**WASTEWATER FACILITIES
PLAN UPDATE**

**TOWN OF TIVERTON
RHODE ISLAND**

JANUARY 2000

Louis Berger Group, Inc.

**Figure 2-1:
TOWN MAP - TIVERTON**

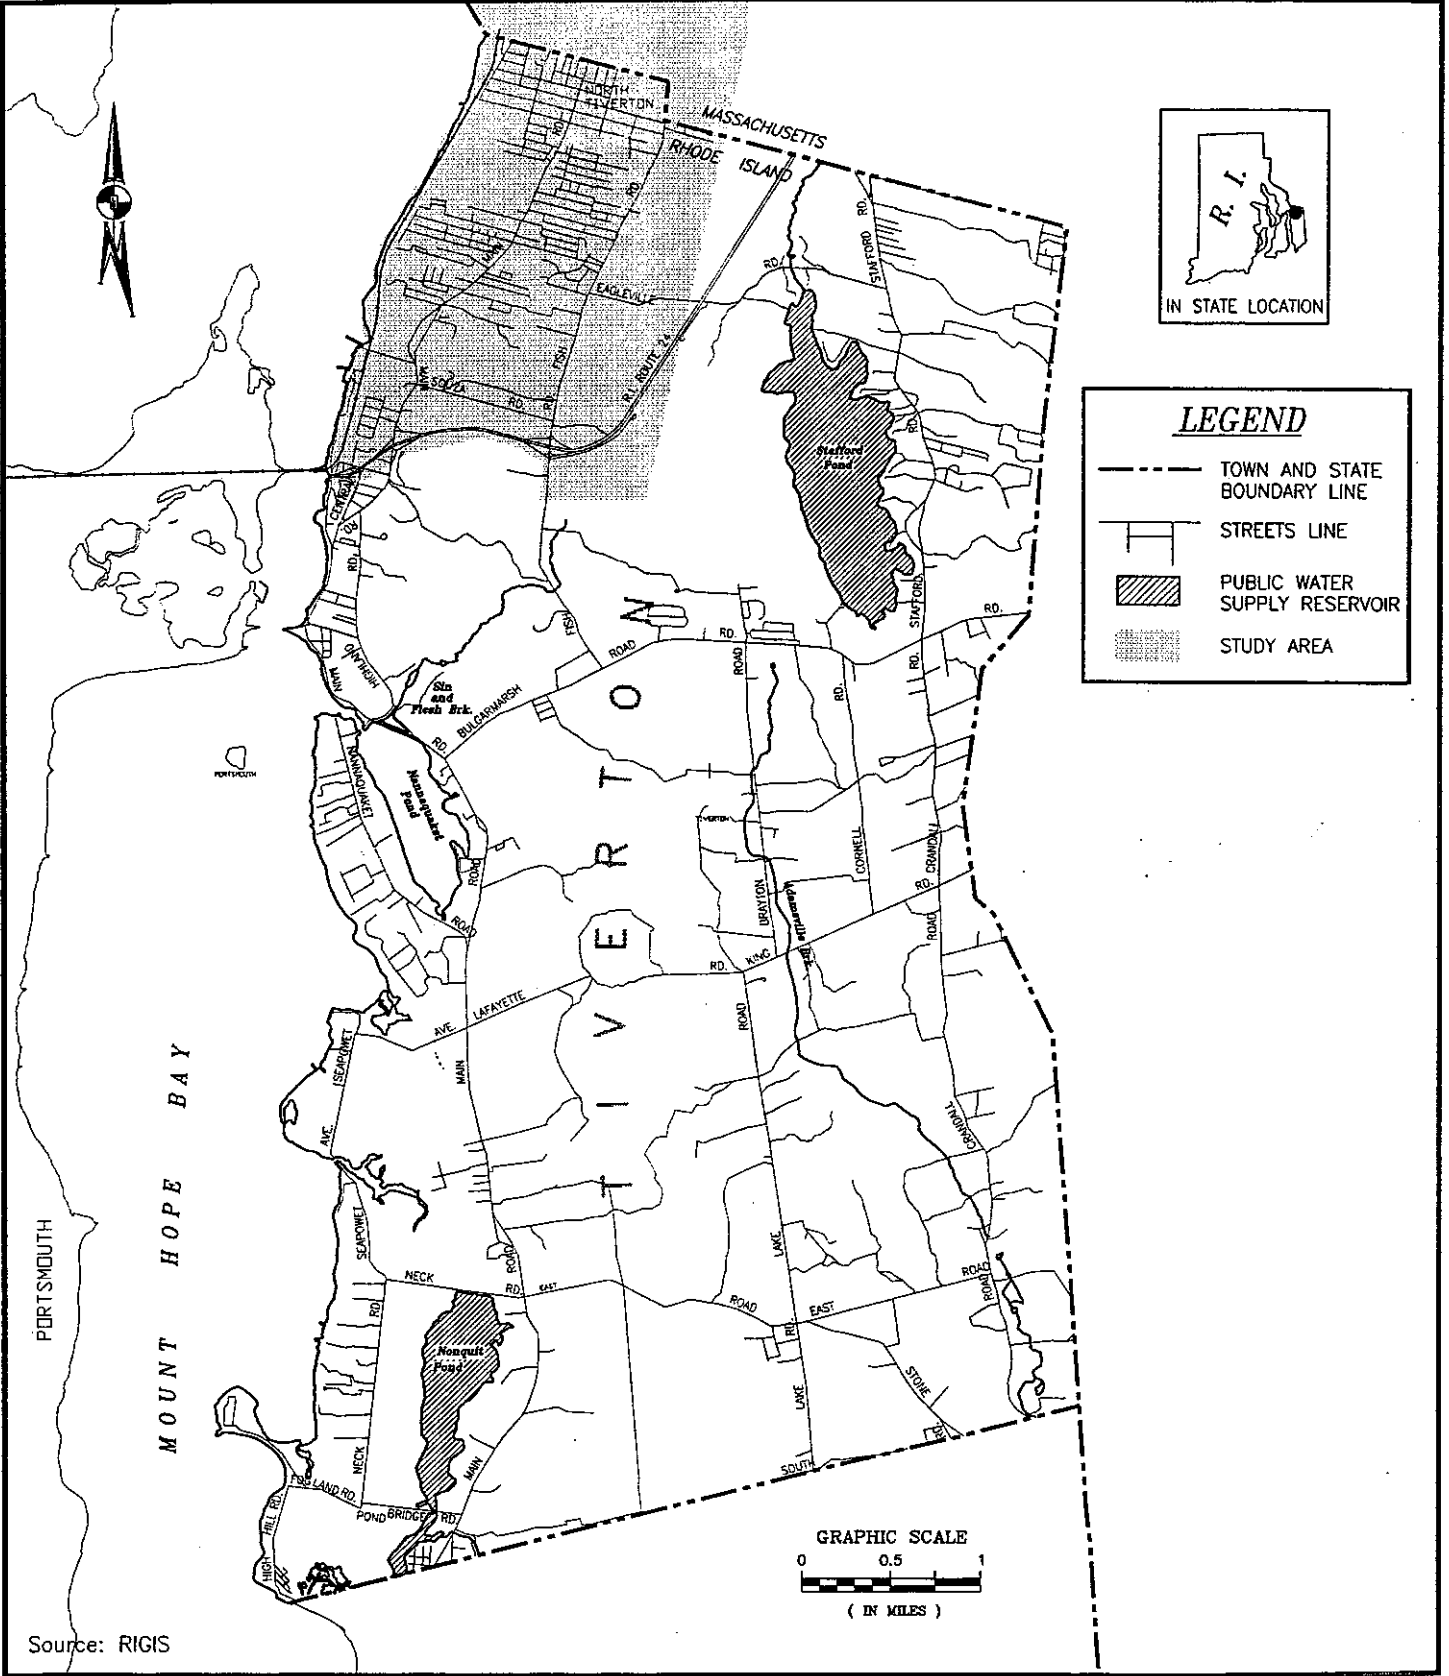
2. **Comment:** In the Executive Summary, revise the text to indicate the study area is the whole town, not just North Tiverton. Also, revise Figure 2-1 to include the whole town in the study area.

2.) In the Executive Summary, revise the text to indicate that the study area is the whole town, not just North Tiverton. Also, revise Figure 2-1 to include the whole town in the study area.

Response: The text has been modified accordingly. In addition, Figure 3-1 has been added.

**Figure 4-5:
PUBLIC WATER SUPPLY
RESERVOIRS**

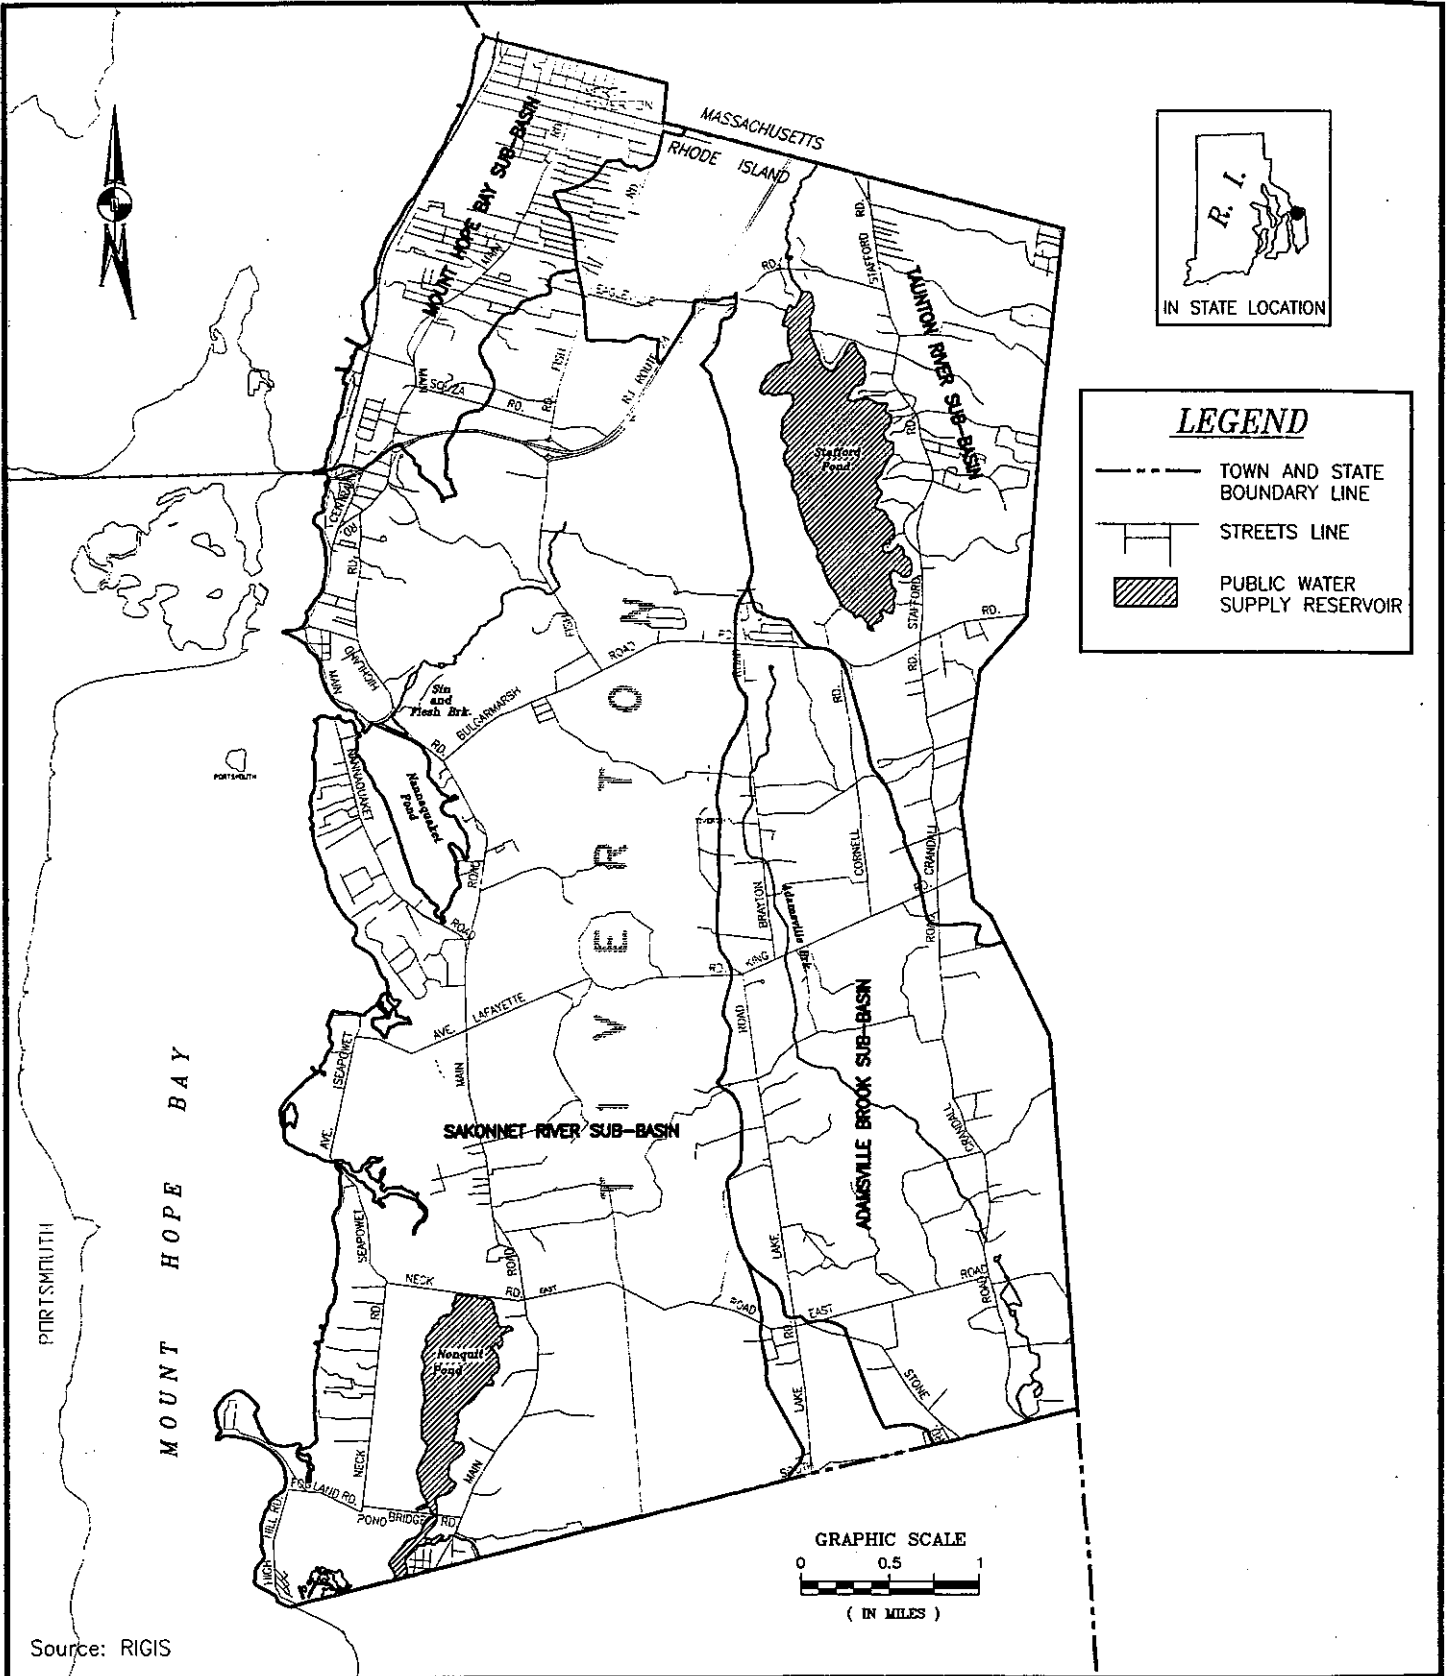
6. **Comment:** On page 4-8, the text states that Figure 4-5 shows the watershed basins for Stafford Pond. However, the Figure does not appear to show any watershed basins. Please revise the text and/or Figure 4-5 accordingly.

6.) On page 4-8, the text states that Figure 4-5 shows the watershed basins for Stafford Pond. However, the Figure does not appear to show any watershed basins. Please revise the text and/or Figure 4-5 accordingly.

Response: Figure 4-5 has been modified to include the watershed boundaries.

Figure 7-1:
SEWERING ALTERNATIVE #1

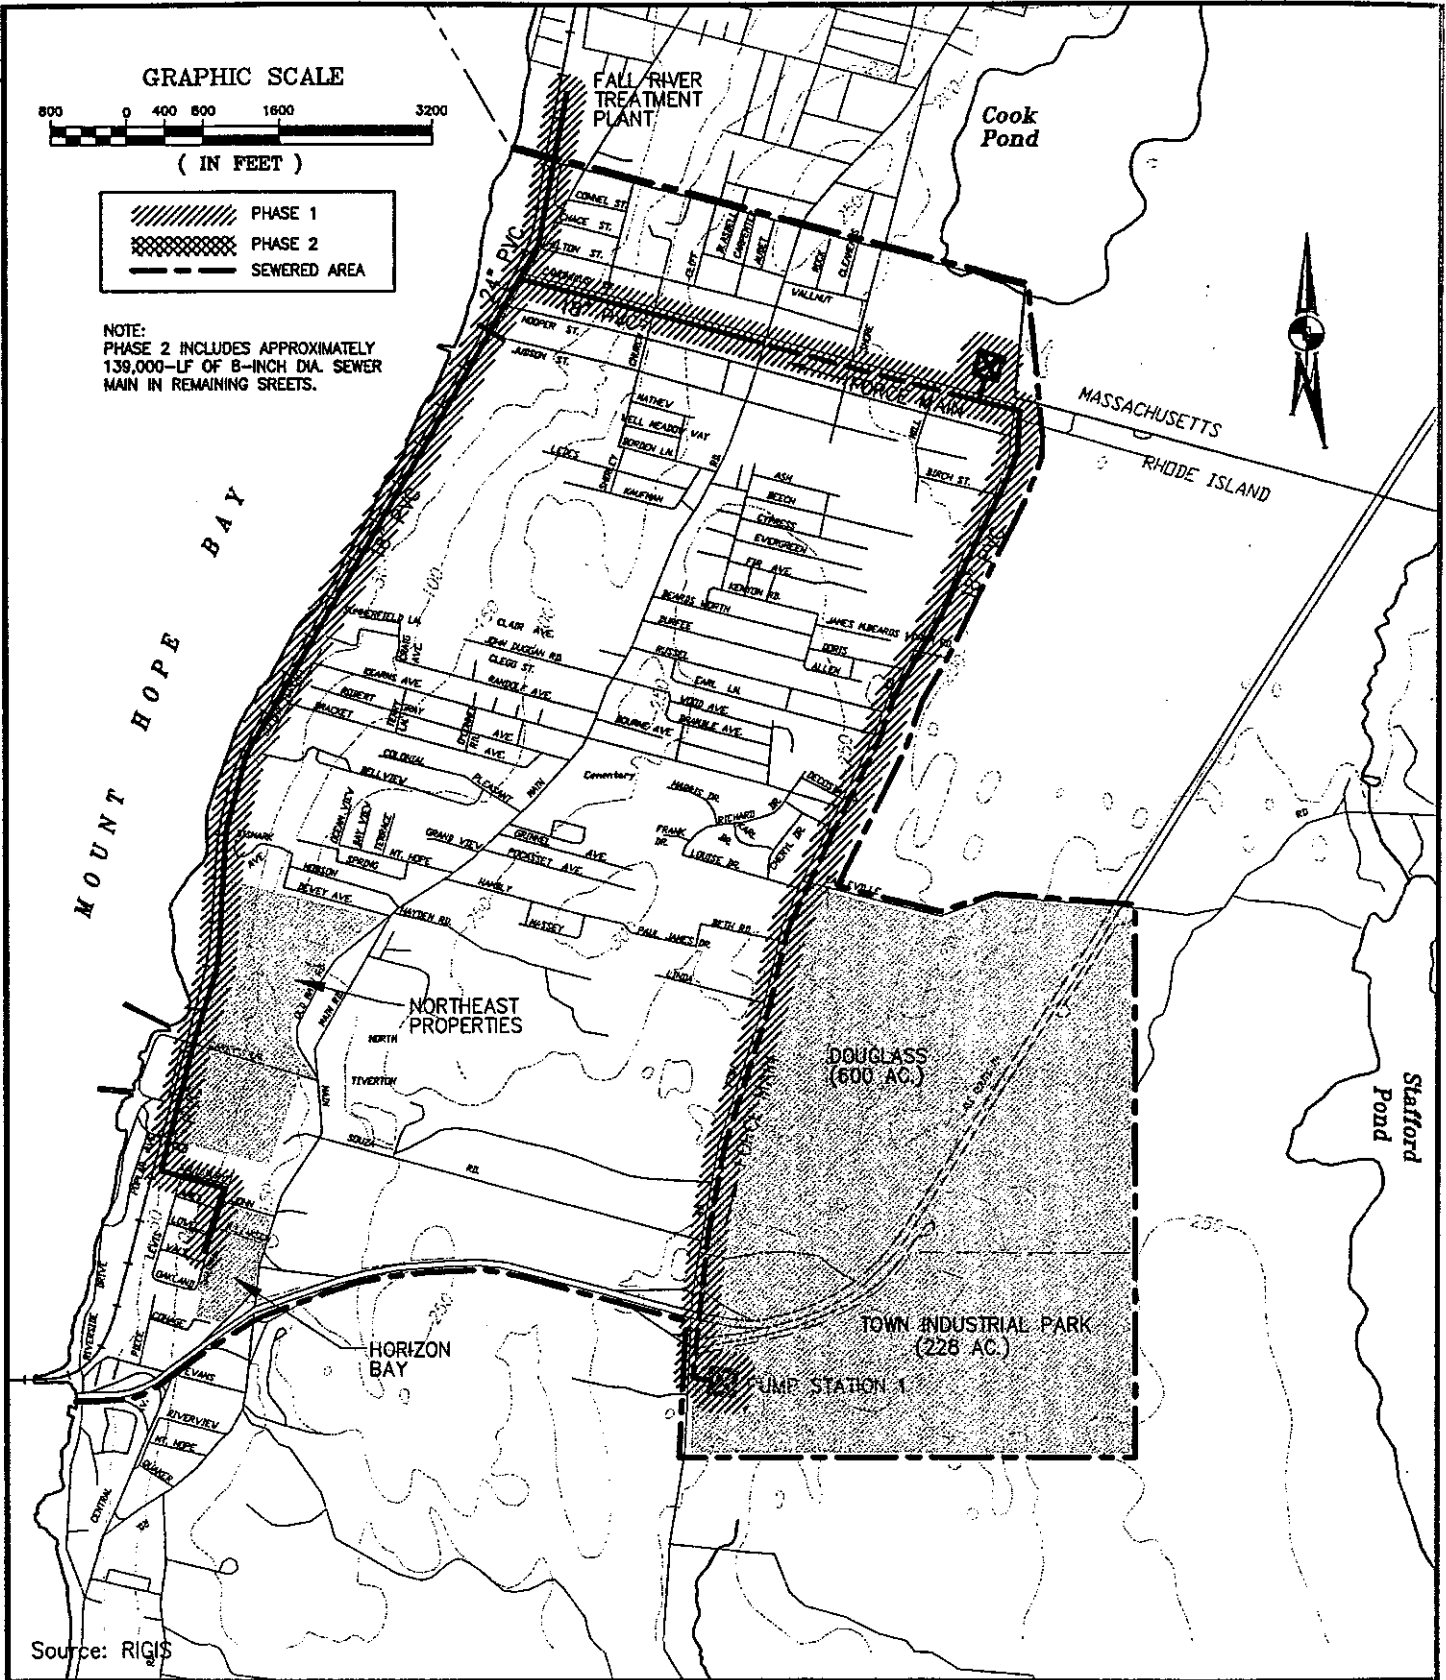
determining the selected alternative. Also, in Section 7.4, please revise the cost estimates to include O & M costs and present the overall cost on a Present Worth or Equivalent Annual basis. Please also provide an ENR construction cost index that can be associated with the costs presented. On Figures 7-1 through 7-3, please indicate which facilities will be constructed under which phase.

Response: Sections 7.4 and 7.5 have been added to include discussions on Environmental Impacts and Short-Term Construction Impacts for each of the proposed three sewer alternatives. Also, Table 7-2 has been modified to include O&M cost for the collection system and a present worth analysis considering O&M costs. Figures 7-1 to 7-3 have been modified to illustrate the phased approach.
